**ADDENDUM NO. 2**

**MONTE VISTA ELEMENTARY SCHOOL  
INTERIM HOUSING PROJECT  
GLENDALE UNIFIED SCHOOL DISTRICT**

DSA Appl. No.03-121306  
DSA File No. 19-41

**RESPONSES TO PRE-BID RFI'S**

BB CONCRETE THRUST BLOCK DETAILS  
NOT TO SCALE

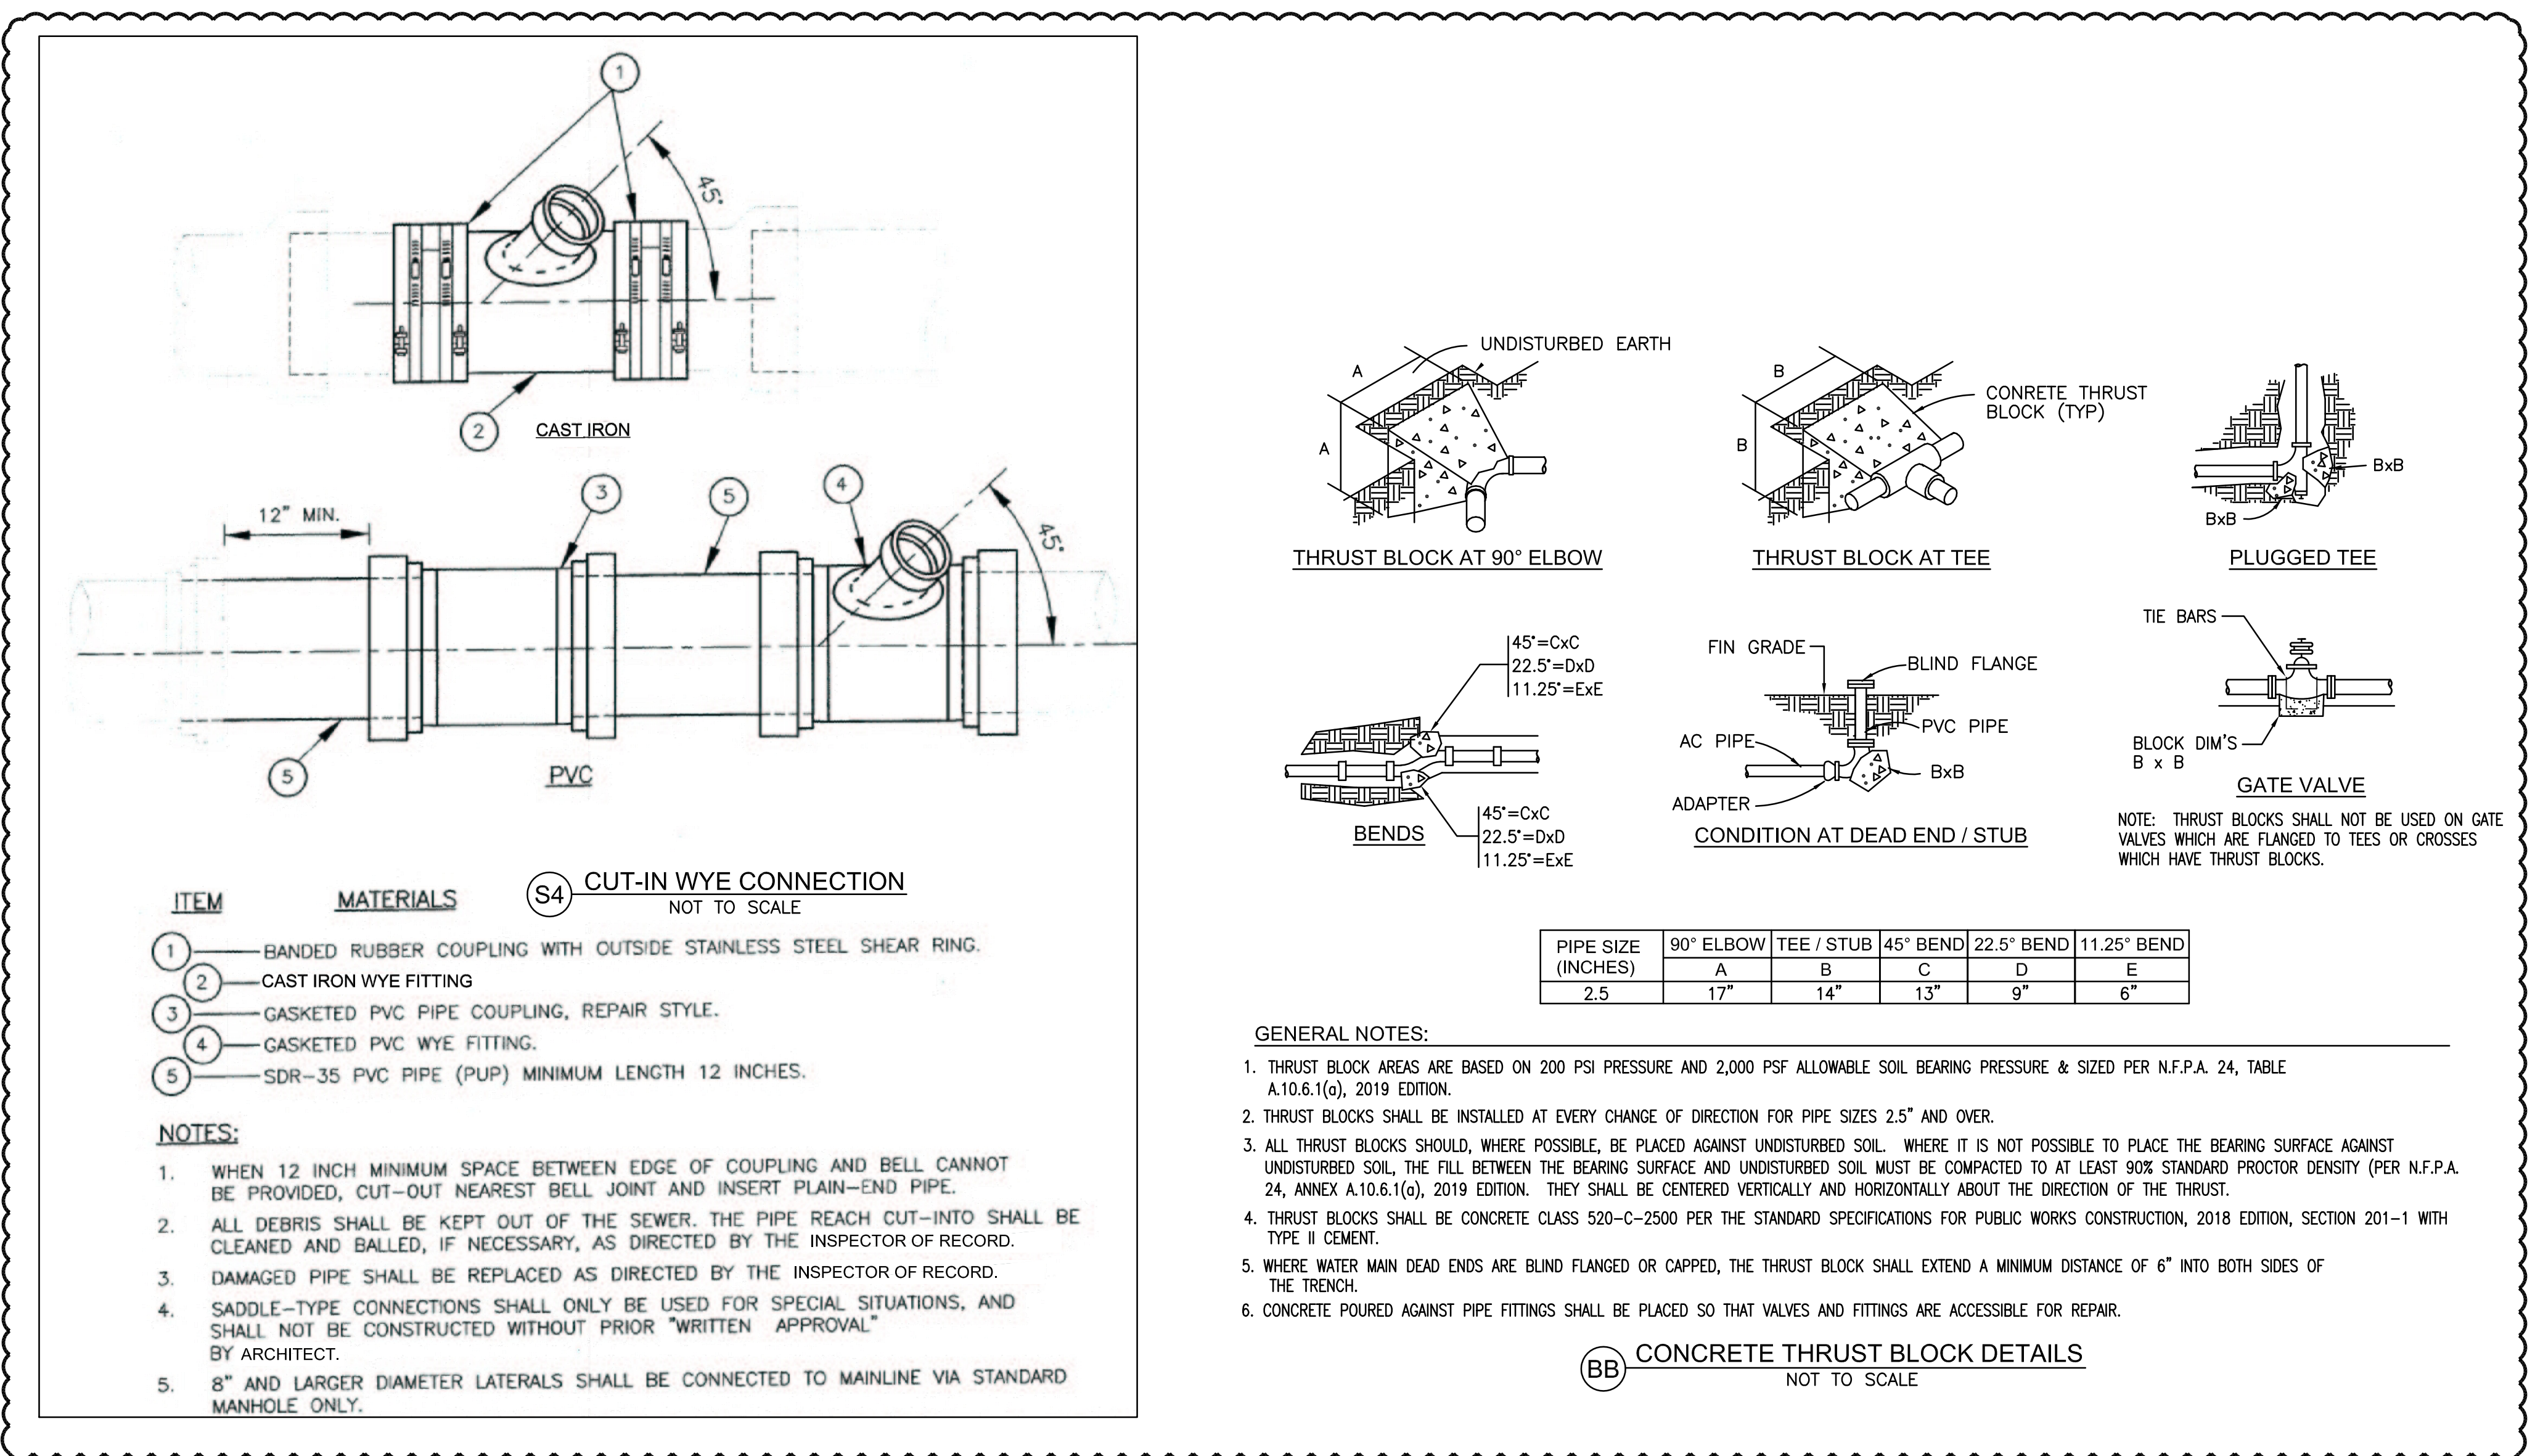
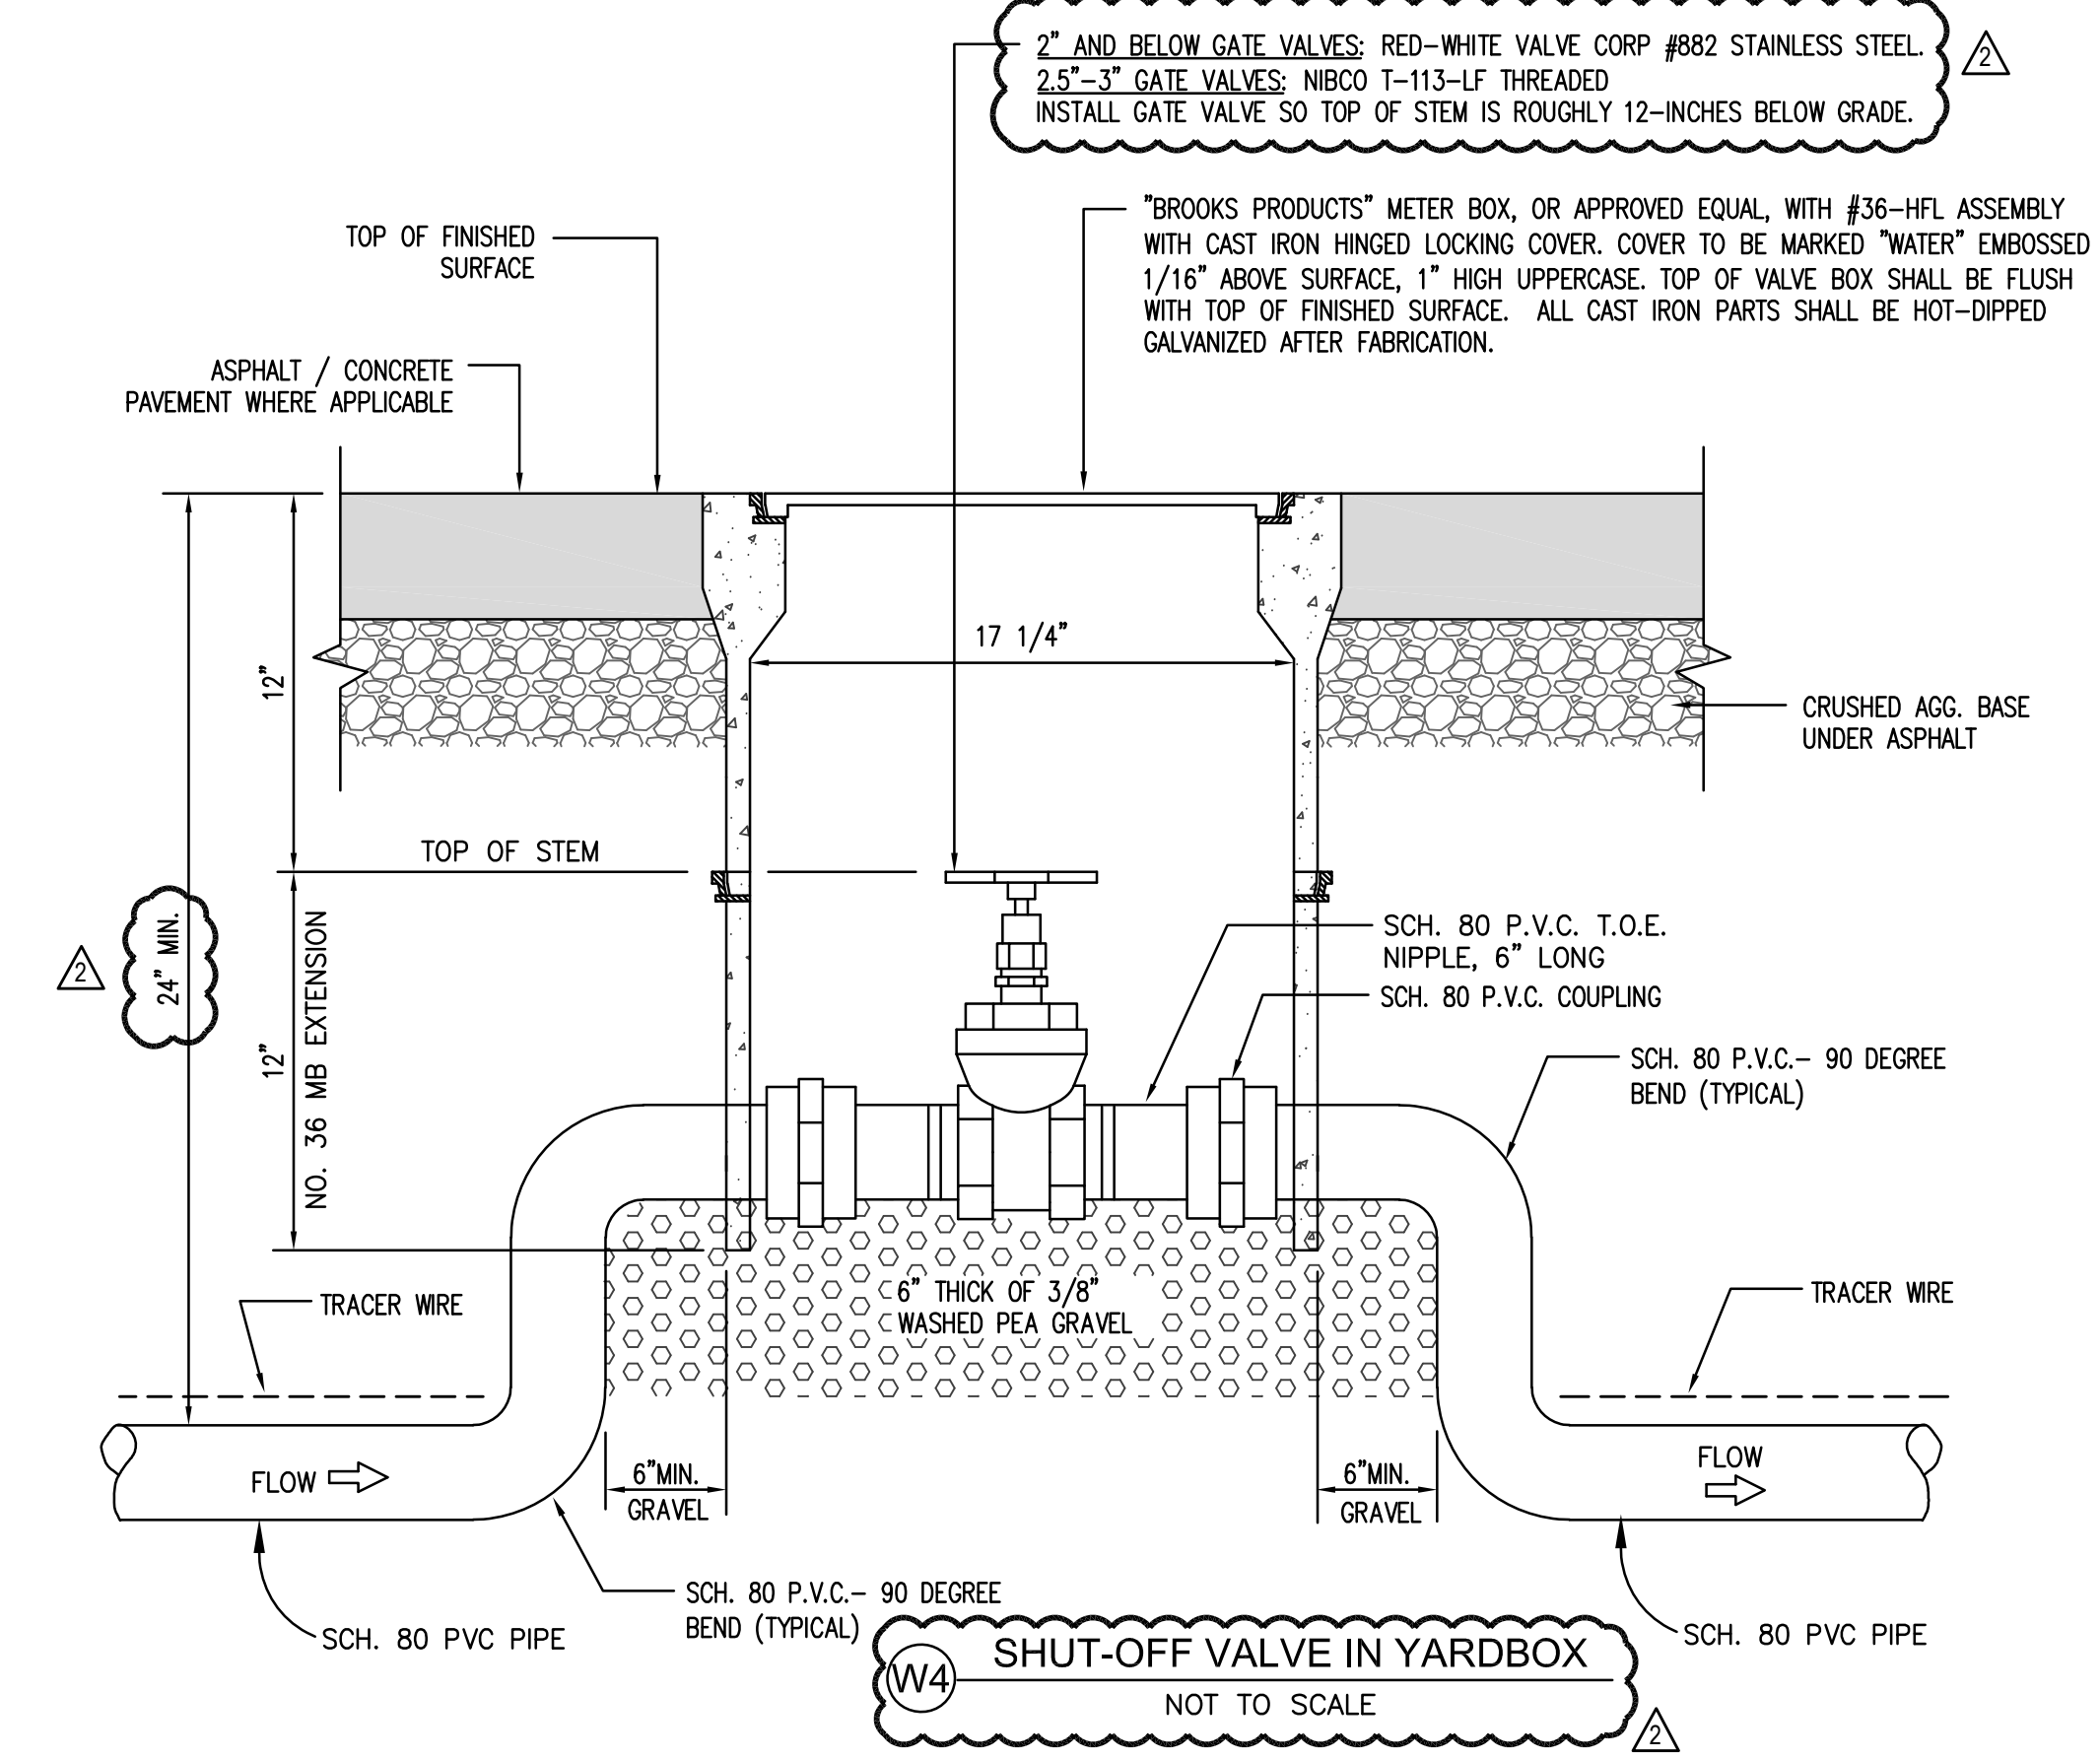
**Response** – Refer to Addendum No. 2 for sanitary sewer changes.
2. Reference Sheet C004  
Thrust block at changes in direction for sanitary sewer are not part of the design. Please advise if this is required.

**Response** – Thrust blocks are not required on sanitary sewer line.
3. Reference Sheet C004
  1. Sheet E0.2 Note #6 E2.1 Note #5 state that the exact location of the sewage ejector control panel location is on the civil drawings. It is not.

drawing title:  
DETAIL SHEET  
drawing no.:  
C005  
drawing of

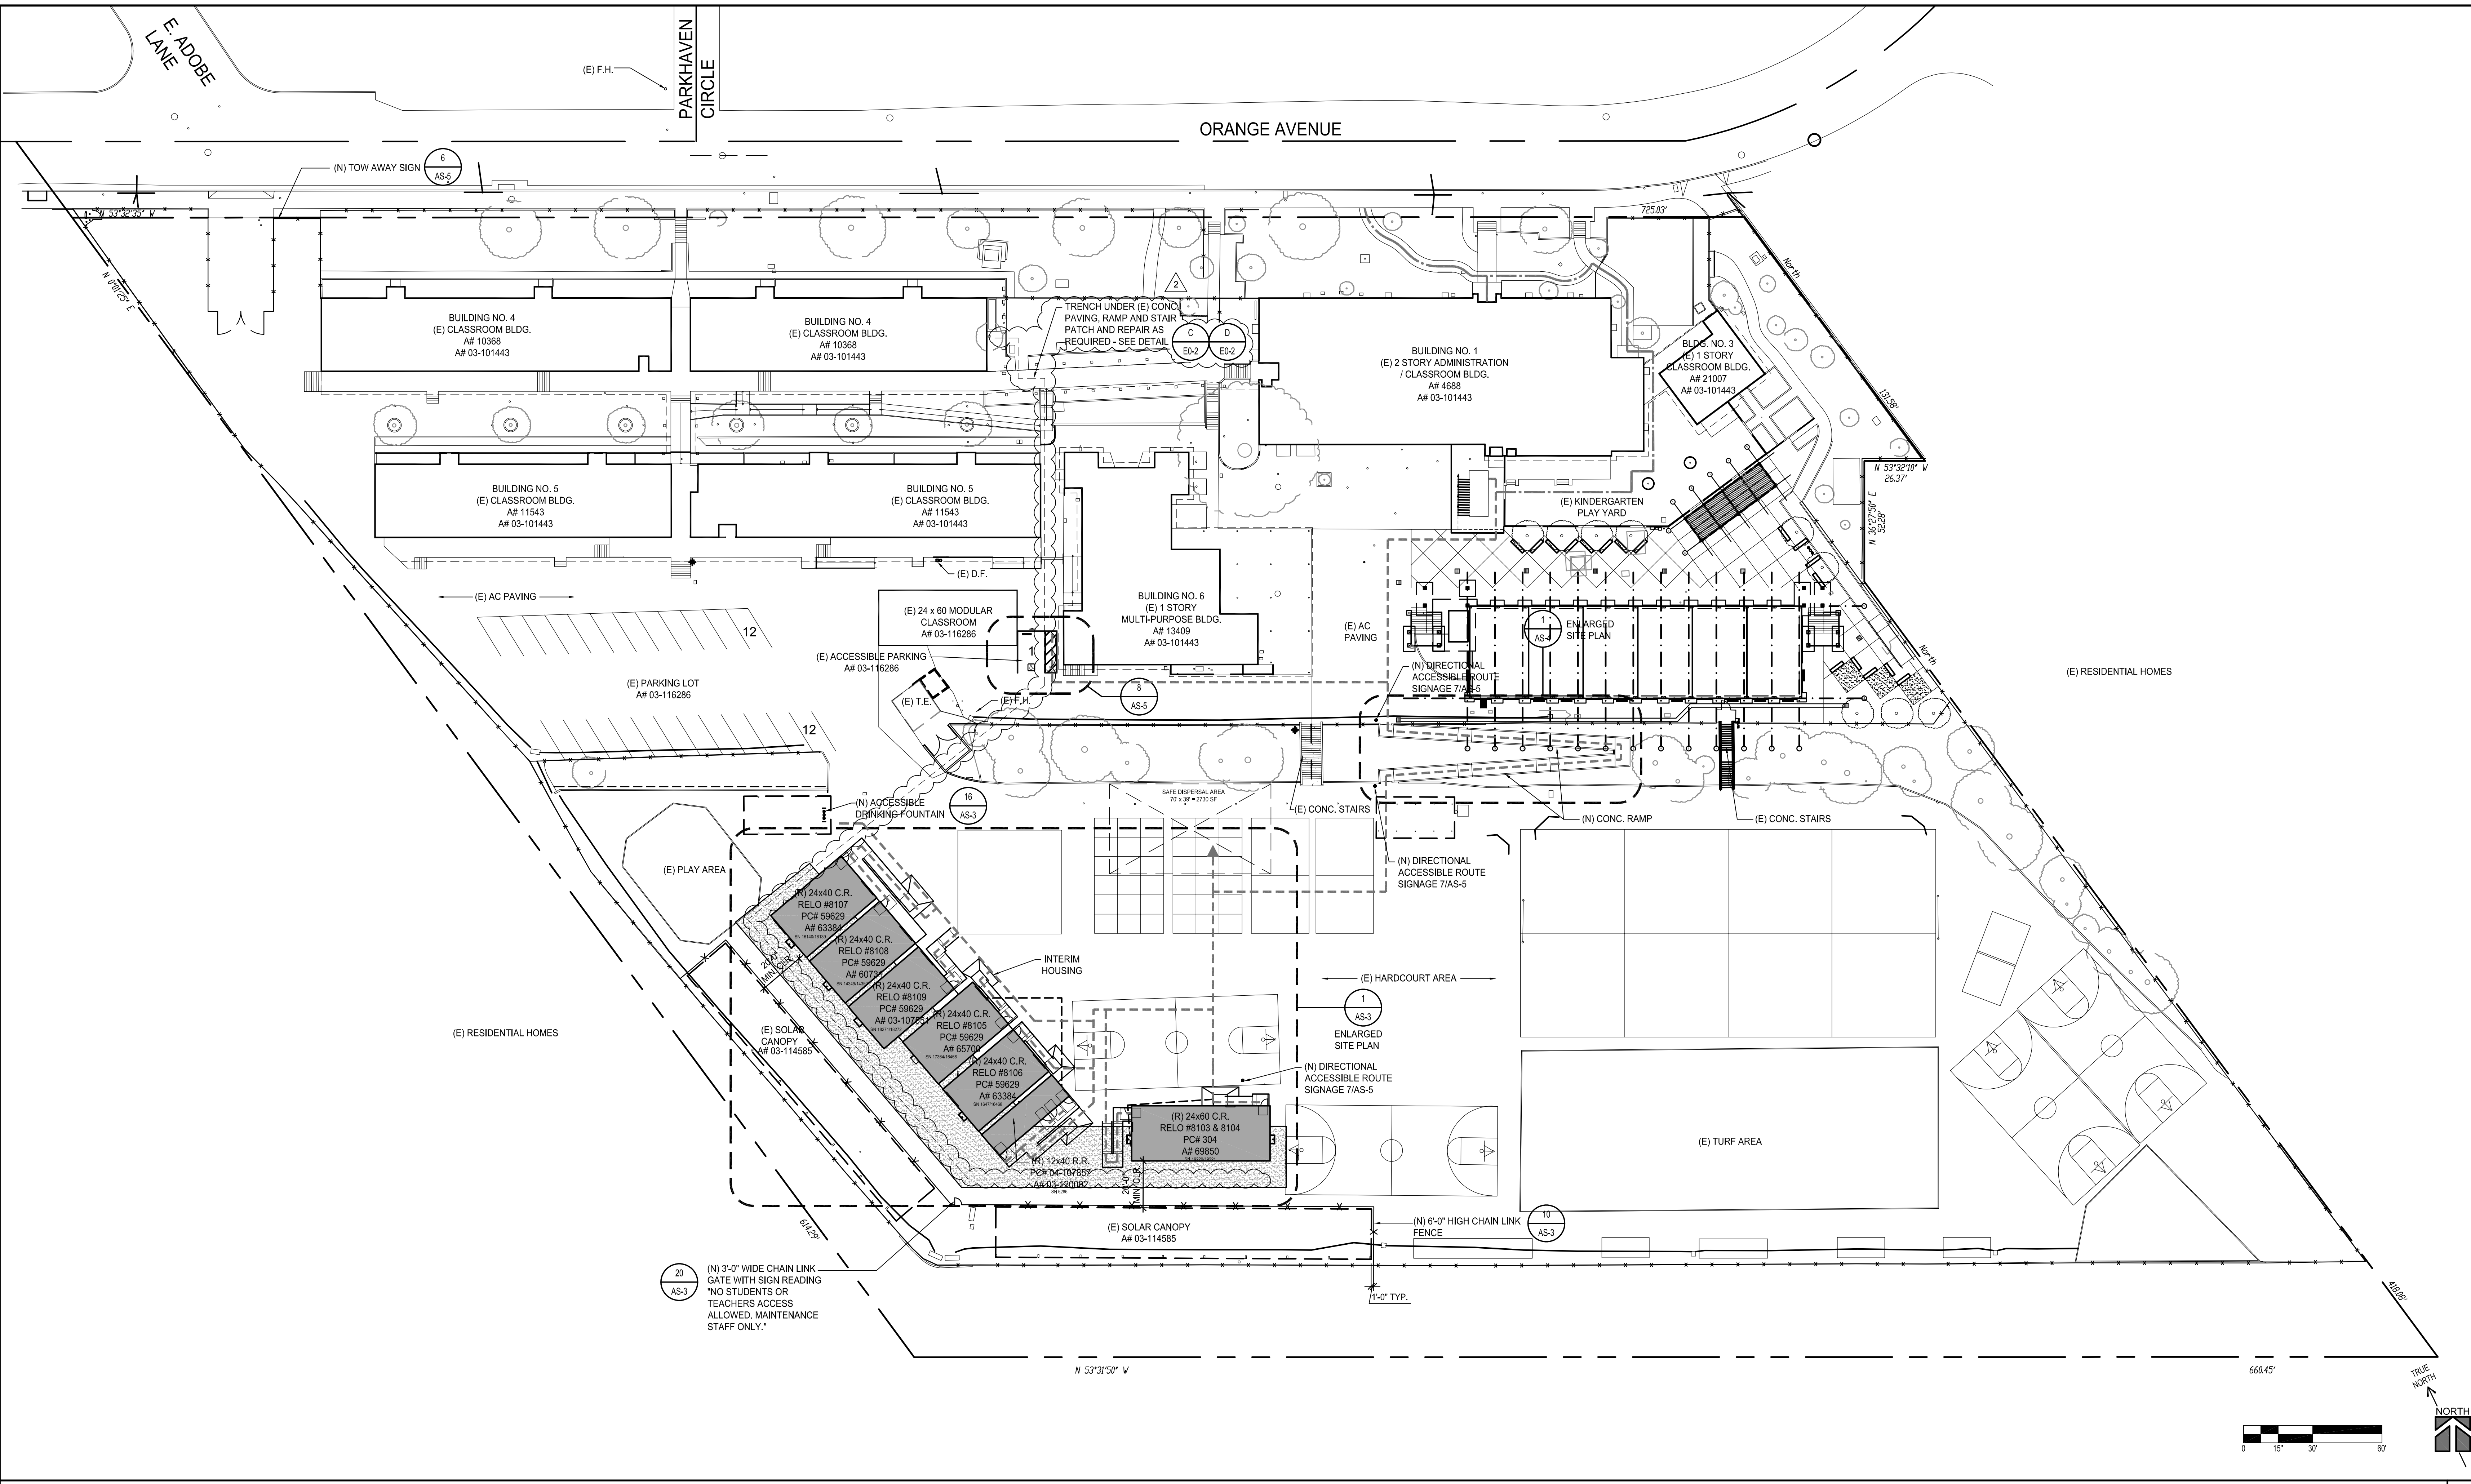
1. SHEET C004 – UTILITY PLAN  
Removed sanitary sewer ejector pump, updated keynotes, updated the potable water construction notes and added AC ramp transition notation.
2. SHEET C003 – GRADING PLAN  
Revised construction note No. 3.
3. SHEET C005 – DETAIL SHEET  
Revised detail for shut-off valve in yard box and added thrust block details.
4. SHEET AS-1 - OVERALL SITE PLAN  
Showing location of electrical trenching.
5. SHEET AS-5 - NEW CONCRETE RAMP  
Added splice and drainage requirements for retaining walls.
6. SHEET 2.01 – DETAILS  
Revise drywell detail 17/2.01.
7. SHEET E0-1 – SYMBOL LIST, GENERAL NOTES & DETAILS  
Revised grounding detail reference as shown on plans.
8. SHEET E0-2 – SINGLE LINE DIAGRAM
  - a. Deleted the feed to sewage ejector pump in Distribution Switchboard “DBR2”
